ADDENDUM NO. 4
November 3, 2022

RE: Component 5: Liquid Transloading Facility - Mechanical and Electrical Work at Facility One

FROM: Tina Perkins, Construction Administrator
Toledo – Lucas County Port Authority
One Maritime Plaza
Toledo, Ohio 43604-1866
Website: toledoport.org
P: (419)243-8251

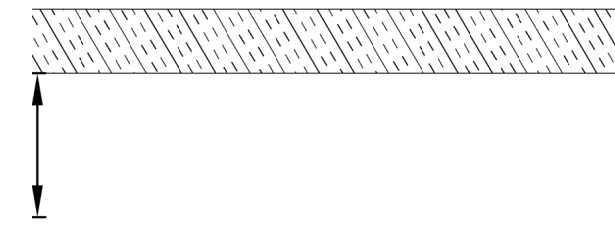
3. **Question:** On drawing MT-101-5023 the transformer plan and section call for 6x6 6/6 WWF does the engineer really want 6/6 wire or do they want 2.9/2.9 wire?

Answer: The 6/6 wire is correct.

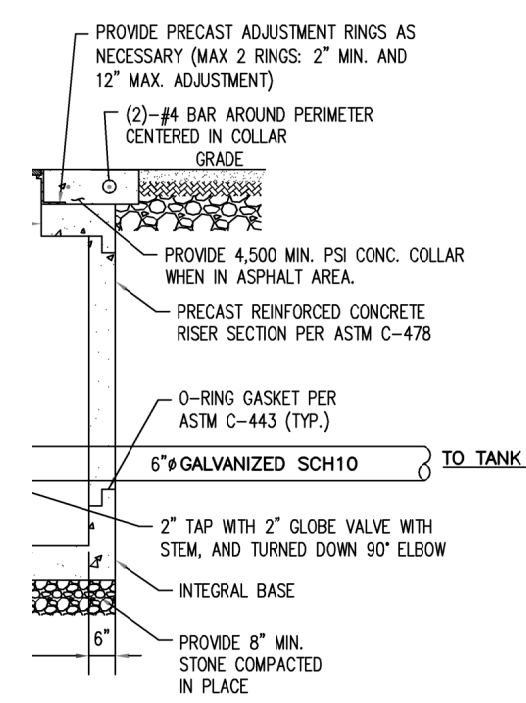
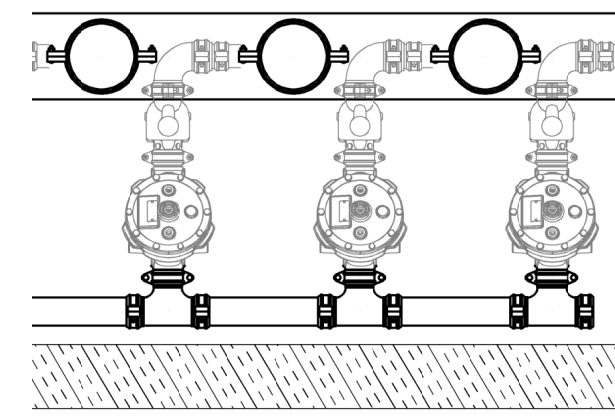
2. Fire Protection Drawing – Updated - (SEE ATTACHED)
 - Fire Sprinkler Plan – FP-1
3. CSX Transportation – SS500 Diagram (SEE ATTACHED)
 - Diagram: Loading or Unloading Combustible and Flammable Liquids or Flammable Gasses.
4. Form of Proposal – Revised (SEE ATTACHED)
 - Alternate Bid 2 – Awarded with Component 4 & 6 - ADDED ALTERNATE
 - Ref. A2-0001 – If Granted Award provide (ADD/DEDUCT) for bidding Component 4 & 6: Civil, Structural and Fire Suppressions Site Work at Fac. 1
